MINOR SITE PLAN
CITY OF PORTLAND, MAINE
SITE PLAN REVIEW
Processing Form

Re: First Baptist Church Revisions

STORMWATER MANAGEMENT REPORT
FOR
FIRST BAPTIST CHURCH
PORTLAND, MAINE

PLANNING REPORT #112-86

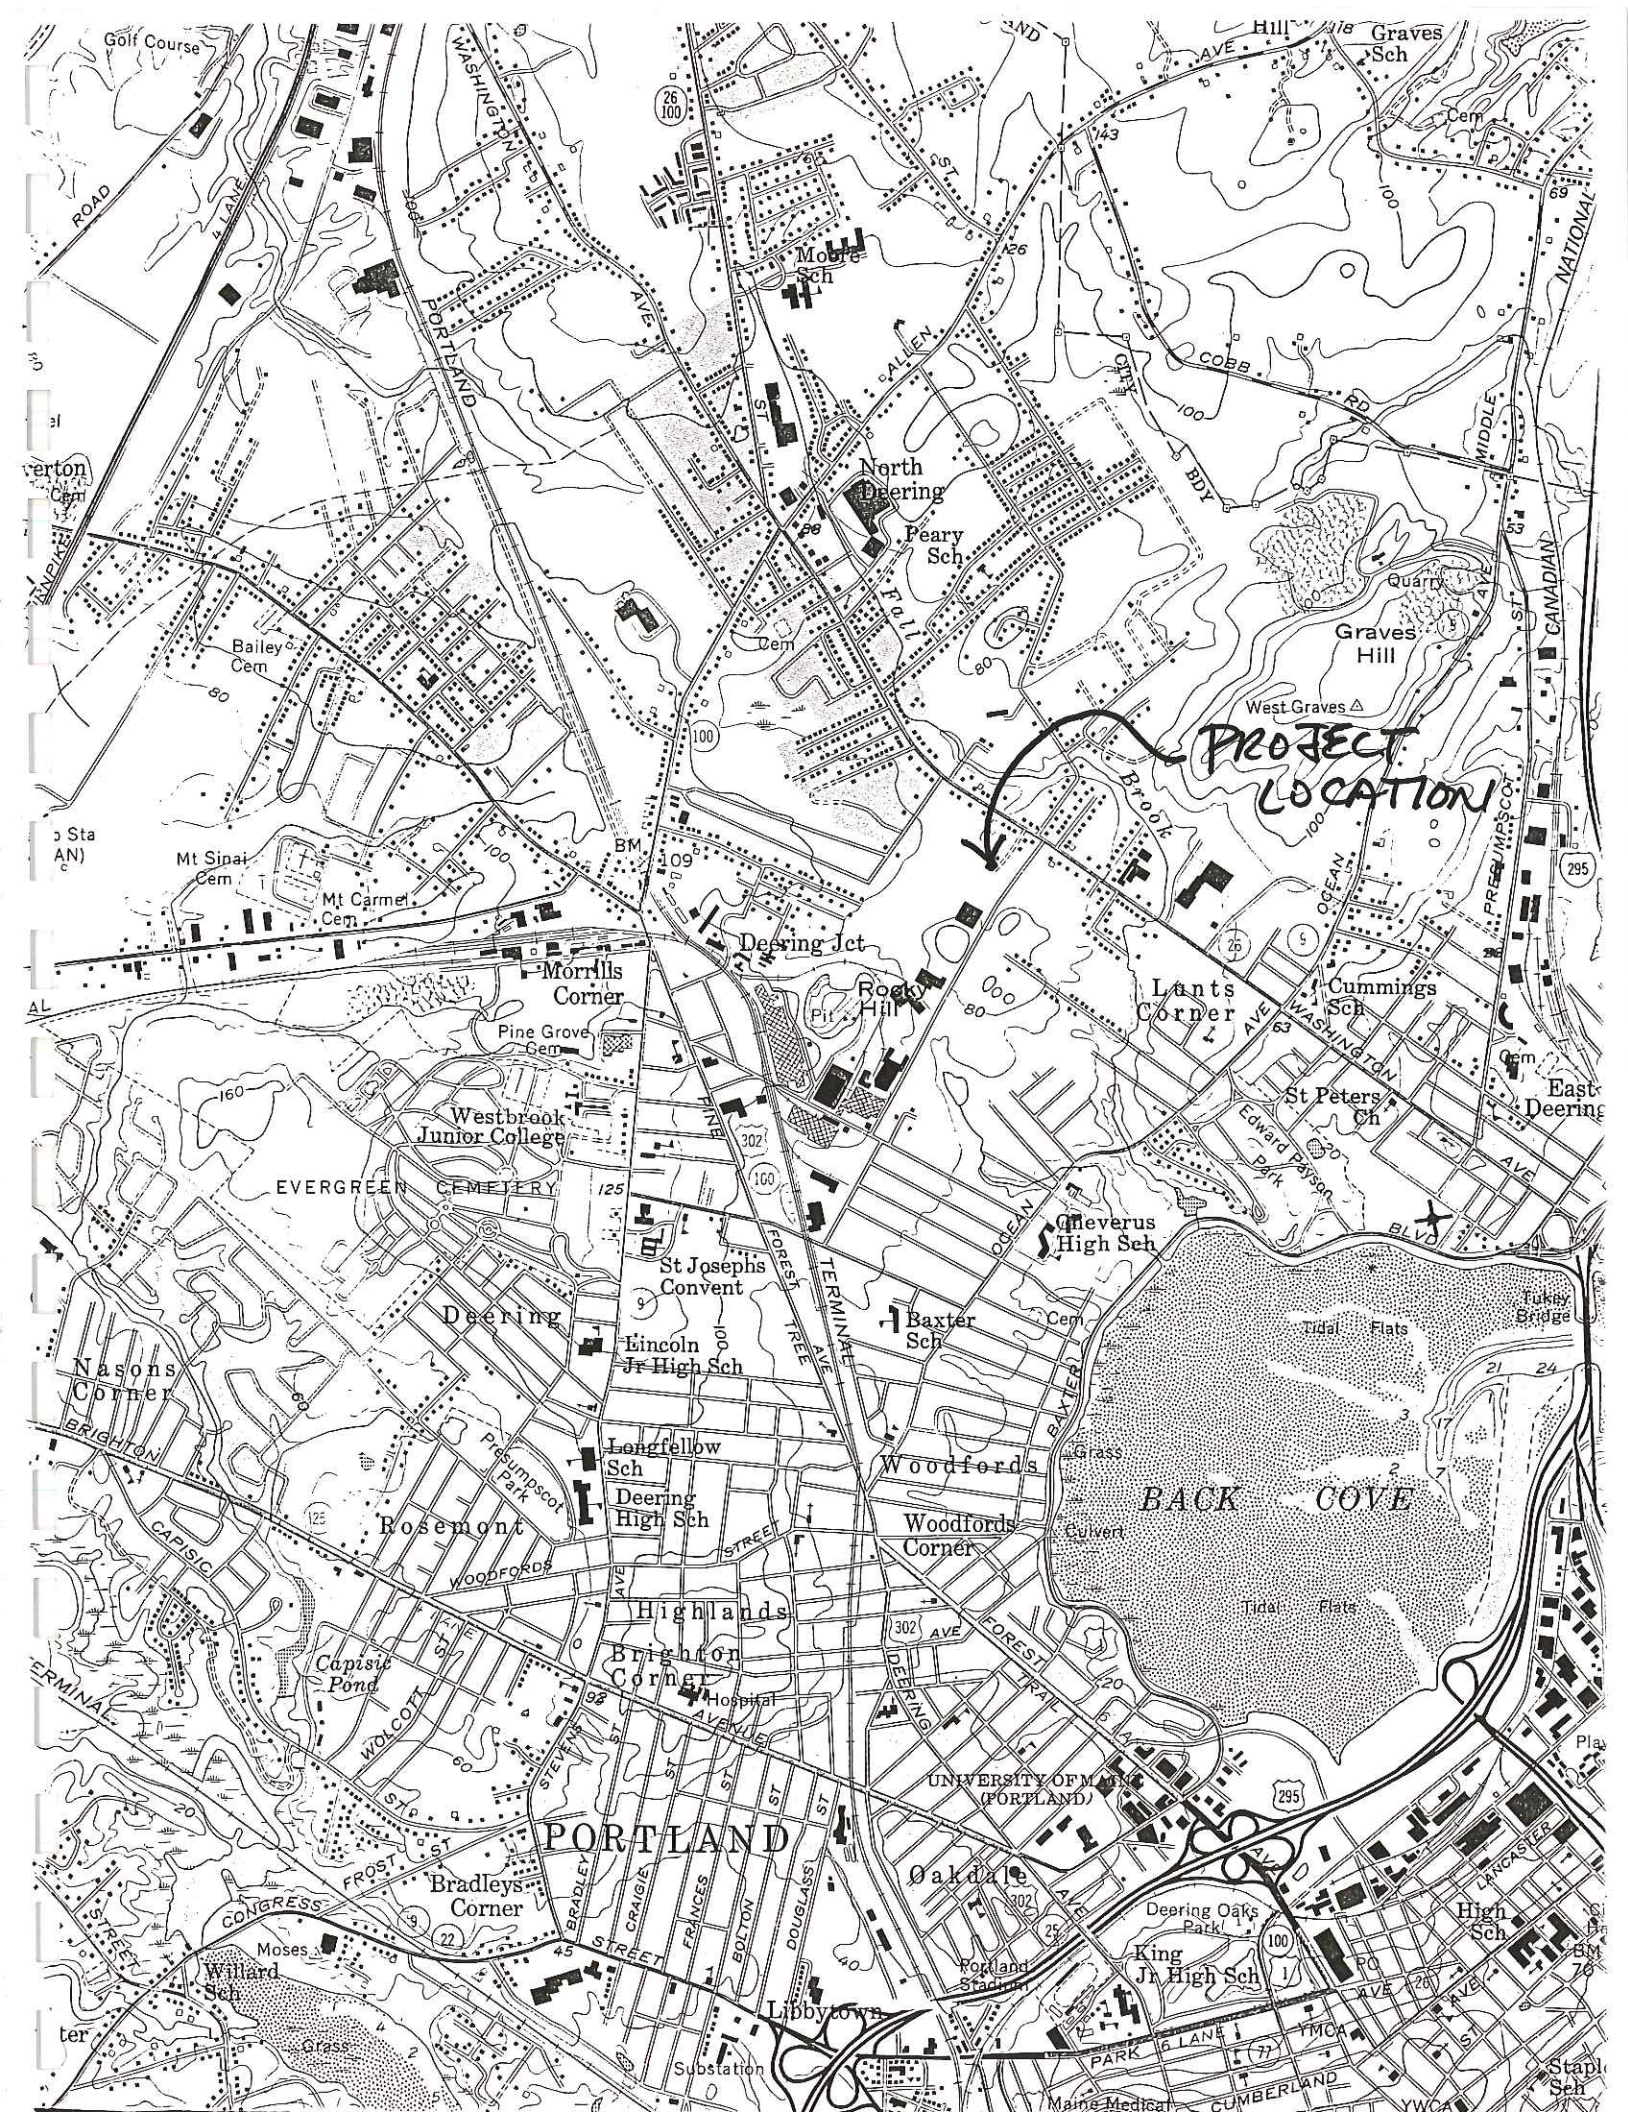
- the preferable location to drain the parking lot addition would be the wet area to the southwest;
- the stormwater report refers to a Hunter Ballew report from 1985. This report is no longer current as it does not take into account the flooding problems associated with Fallbrook. Also, the stormwater report does not take into account the drainage from the northern section of existing parking area. The stormwater report should be revised accordingly.
- Please verify the direction of drainage flow in the existing parking area. Staff is concerned that the runoff may not flow as indicated. Please either submit grades in parking area or indicate curbing which will direct runoff to parking lot addition.

Attachment 1

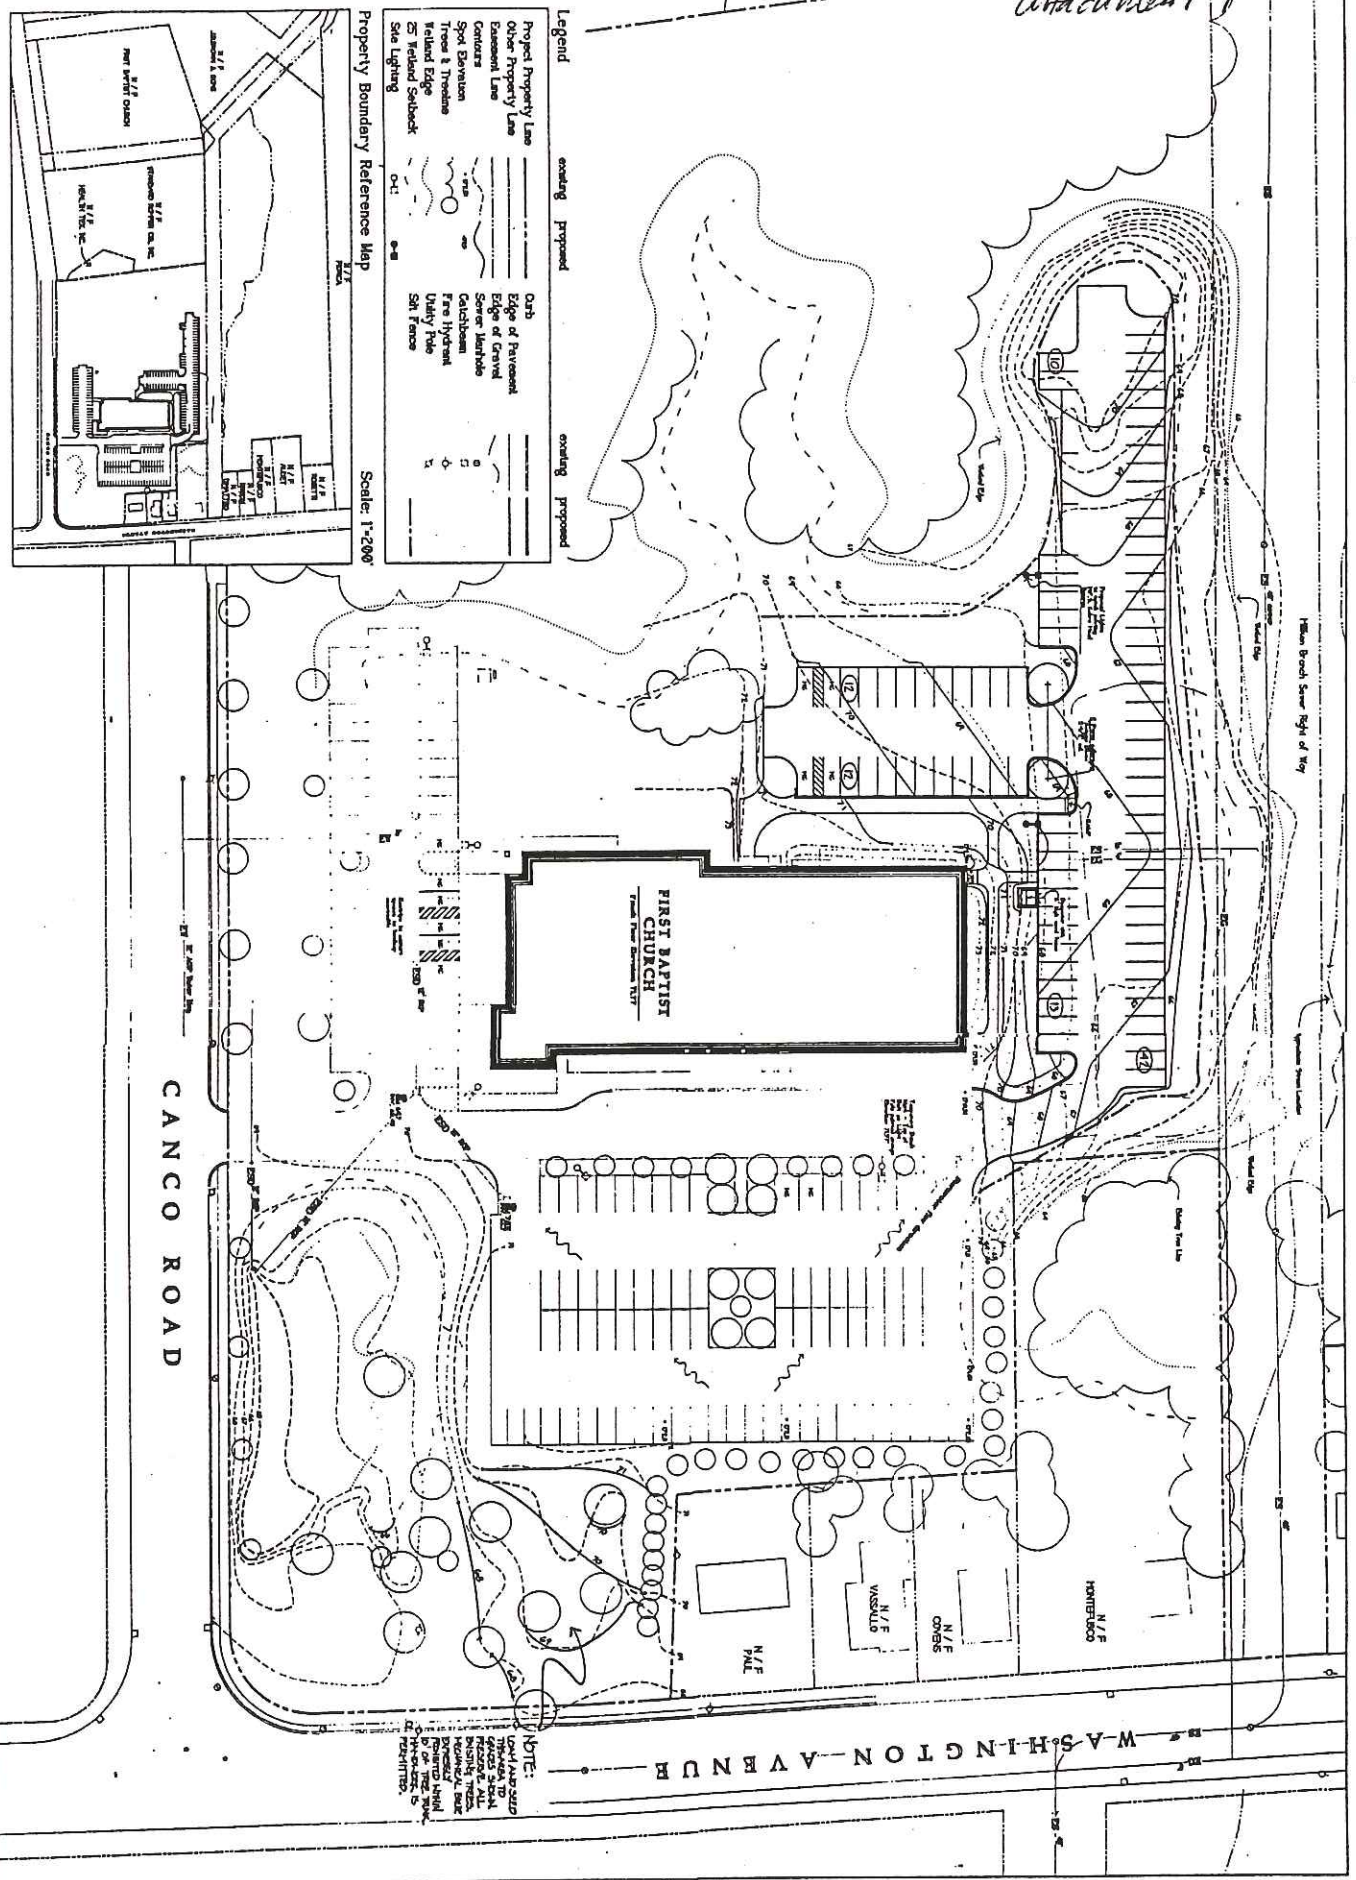
I have reviewed the revised plans in the First Baptist Church. My comments are as follows:

The proposed parking lot has been reduced in scale in order to meet DEP requirements. The disturbed areas within the wetland will be regraded and revegetated. The plans show vegetated buffers that are 25 to 50 feet wide. All stormwater will be filtered by the buffers prior to entering the wetland. Given the limited amount of use that this parking lot will receive, the buffers and wetland vegetation will provide adequate treatment of the stormwater prior to entering the brook.

The revised Stormwater Management Report prepared by BH2M has addressed my concerns regarding stormwater runoff.

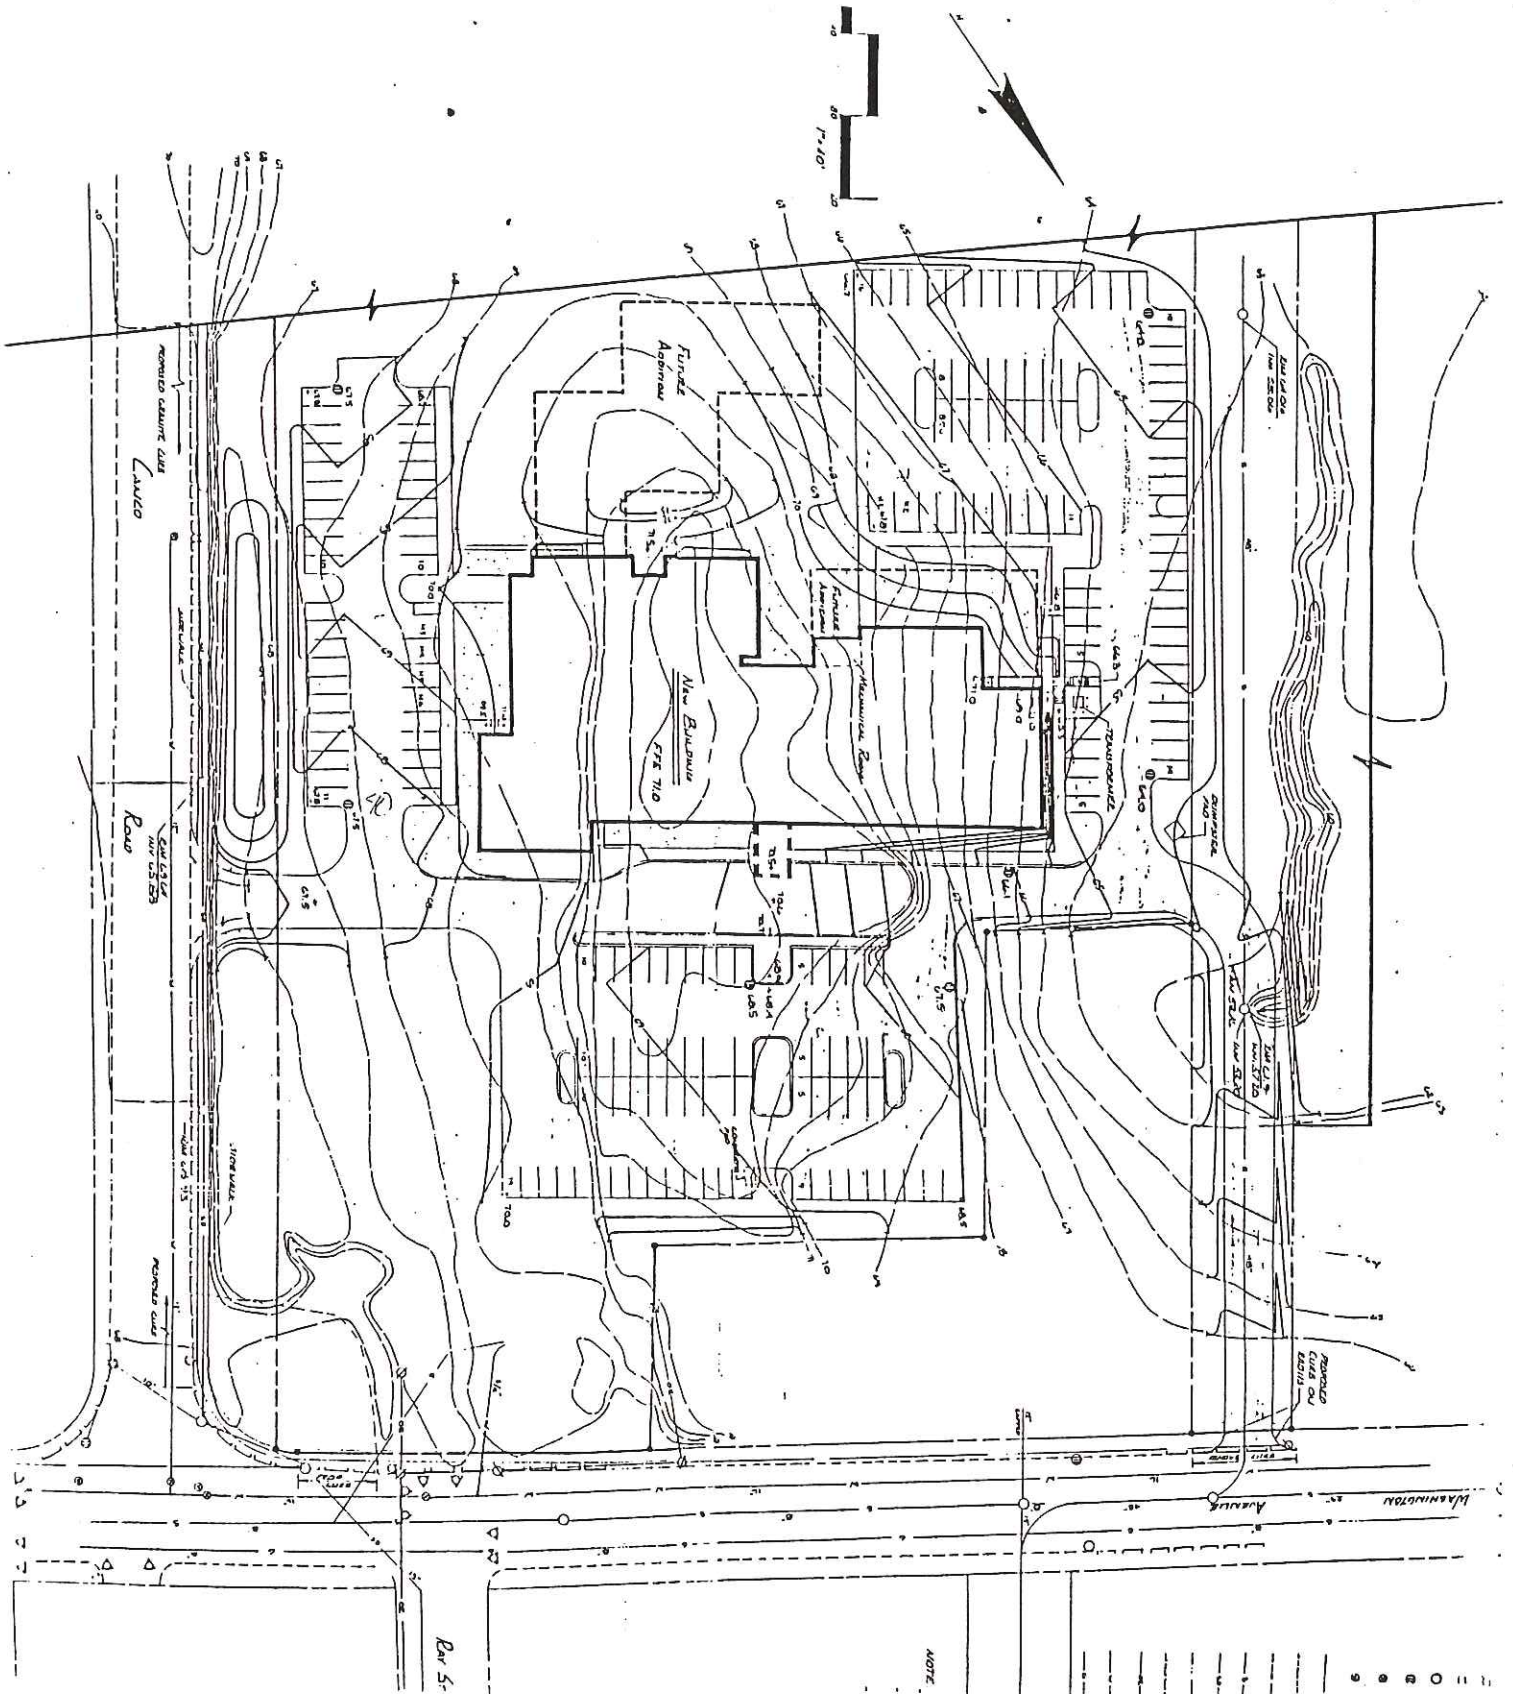
Mr. Bray, the City Traffic Engineer, has reviewed the plan and has concerns regarding the possible development of the remaining portion of the site and access to Washington Avenue. He states in his attached memo that the site plan is unacceptable to the Traffic Department.

Mr. Robert Roy, City Planning Engineer, has reviewed the stormwater management design of the site and recommends the following conditions of approval:

- a. That the design specifications for the hydro brakes to be installed in the catch basins in the parking lot be indicated on the plan.
- b. That the sidewalk to be built along Canco Road shall be installed along the streetline with a five foot wide grassed esplanade between the sidewalk and curblane.

In reviewing the plans, Carmela Barton, City Arborist, has recommended that the plan be revised to incorporate the following:

- a. That the oaks, which line the driveway, be planted 30 feet on center instead of the proposed 40 feet on center. And that the number of oaks be increased, in this area, from 12 to 16.
- b. That the minimum height of the Austrian pines be 6 feet or if a shorter tree is used, they be planted 10 feet on center rather than 15 feet on center.
- c. That the trees screening the parking lot nearest Canco Road be spaced 25 feet on center and additional evergreen underplanting be planted.
- d. That foundation plantings be provided for the Washington Avenue elevation and the Canco Road elevation.
- e. That a preservation plan be established for the site.

ii. That the hydrobrakes and esplanade be done as per City Planning Engineers' comments.

iv. That the applicant provide underground electric service to the building from the property line.
